**Subject:** Proposed SECY on ROP Enhancement

**Project Number: 689**

## Attachment NEI Comments on ROP Enhancement

In oral remarks, the staff expressed concern about a rising trend in the length of time taken to close a white performance indicator. The trend is depicted in the graph below, taken from slide 14 in the staff’s April 24 presentation package.

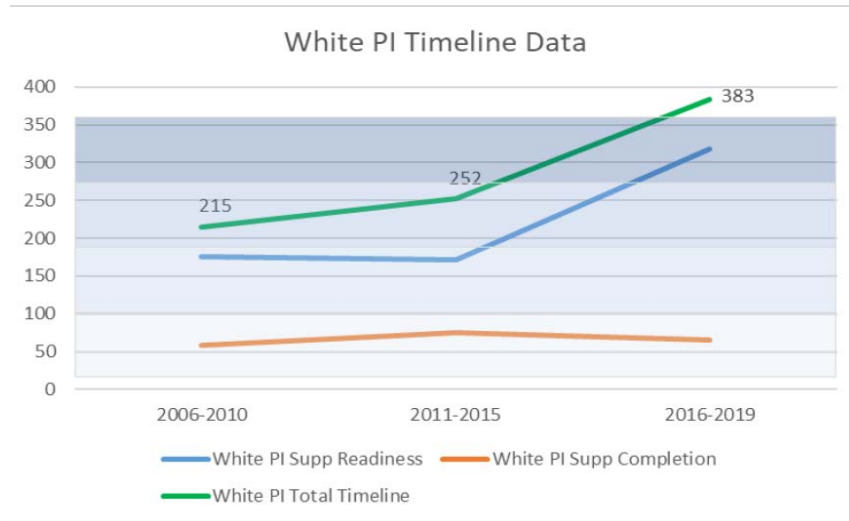
The graph shows a dramatic rise (52 percent) to 383 days to close a white performance indicator in the 2016–2019 interval. In our examination of the staff’s data, we note there has been an even more dramatic reduction (i.e., improvement) in the number of white performance indicators over the period of time shown in the NRC graph. In the interval 2006–2010, we counted 33 occurrences of a white PI in the staff’s dataset; 23 occurrences in the 2011–2015 interval, and only five occurrences in the 2016–2019 interval. The decline in the number of white PIs per interval should be recognized as a substantial improvement in licensee performance since the beginning of the ROP. In the face of this fleet-wide improvement, the staff asserts that a rise in the average number of days to close a white PI in a dataset of just five occurrences is a sufficient basis for the NRC to conclude there is a problem.<sup>14</sup> In our view, the apparent rising average is, at most, a sign that further study is needed (as we explain below, we see extenuating circumstances in the most recent instances). Thus, we do not see in the sparse data proof that a major change is needed in how white PIs are treated in the ROP.

The staff has also asserted that it should not take longer to close a white PI than to close a white finding. Yet, we know that performance indicators and inspection findings are fundamentally different inputs to the ROP, and the licensee and NRC response to both differs in important ways that are not captured in the staff’s metric of average days to closure.
